Title: TOP & POWER			 life.augmente
Project: NUCLEO-XXXXRX			
Size: A4	Reference: MB1136	Revision: C.3	
Date: 9/26/2014		Sheet: 1 of 4

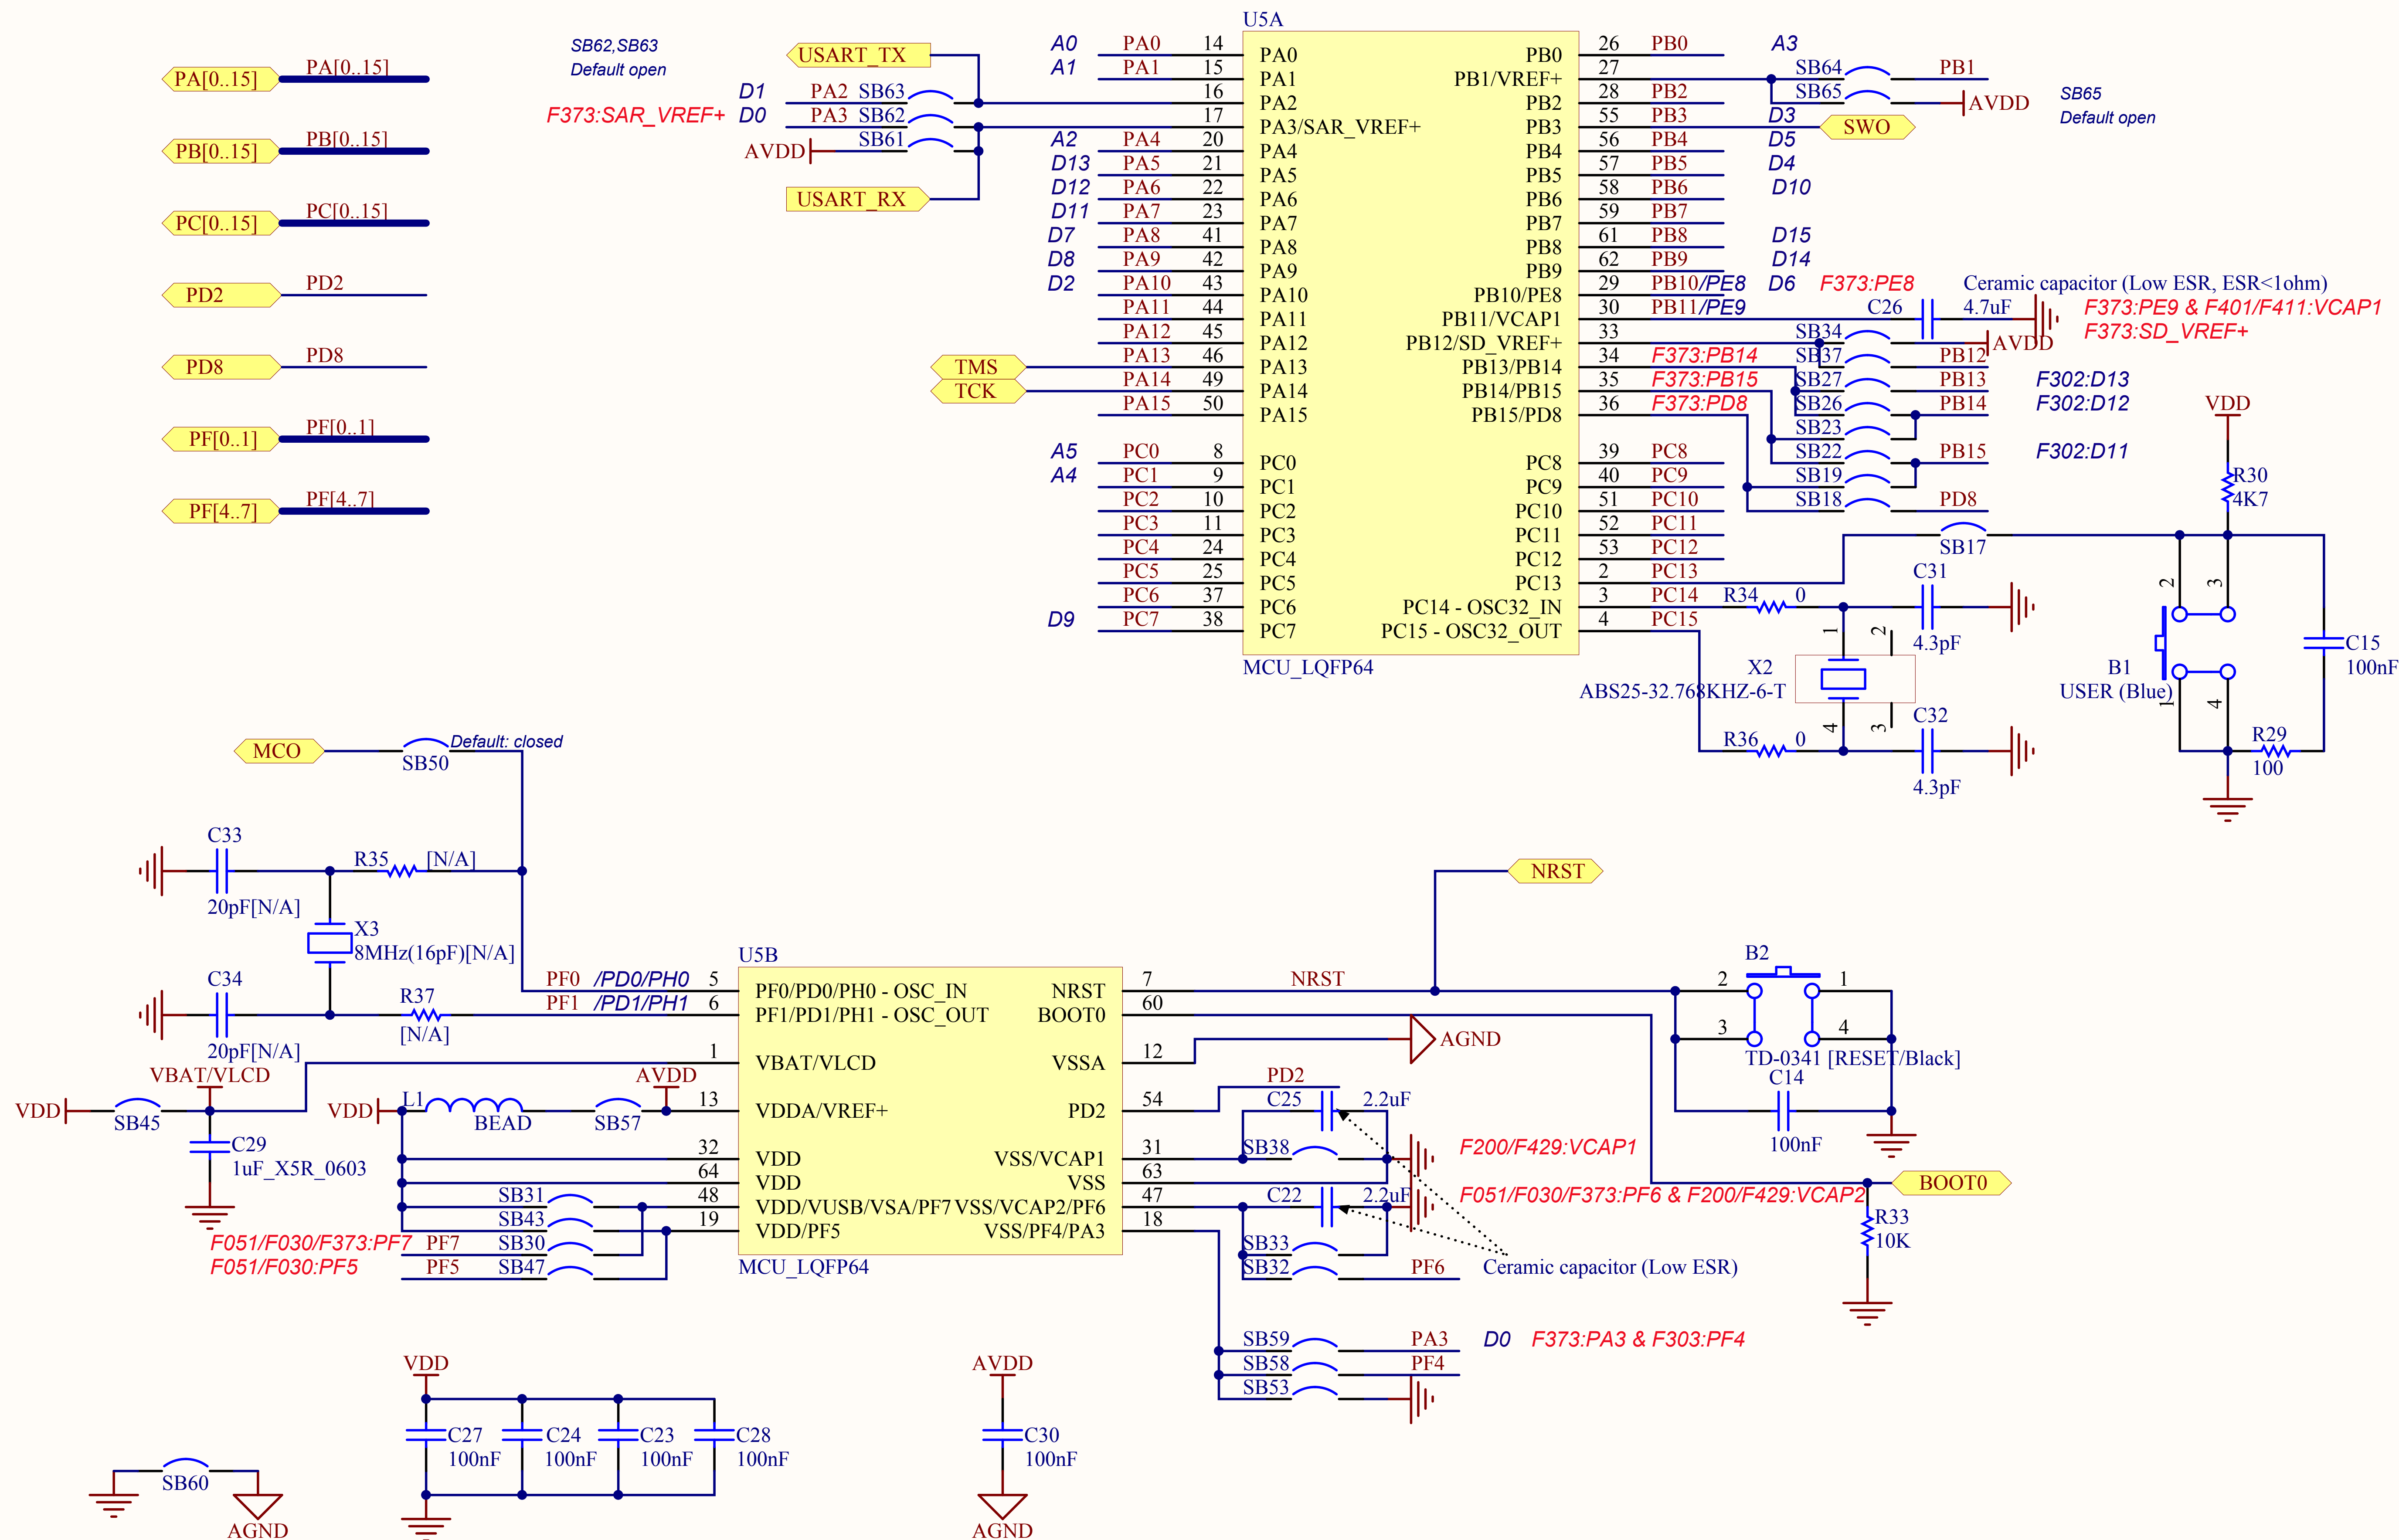
Note1: Text in italic placed on a wire doesn' t correspond to net name. It just helps to identify rapidly Arduino's signal related to this wire.
Note2: Remove [N/A] on R34, R36, C31, C32, X2 from C.1 to C.2
Note3: Add " default open" on SB48, SB49, SB55 from C.1 to C.2
Note4: Replace " default open" by " default closed" on SB16 & SB50 from C.1 to C.2
Note5: C31&C32 value changed from 10pF to 4.3pF to fit with new 32K crystal ABS25-32.768KHZ-6-T
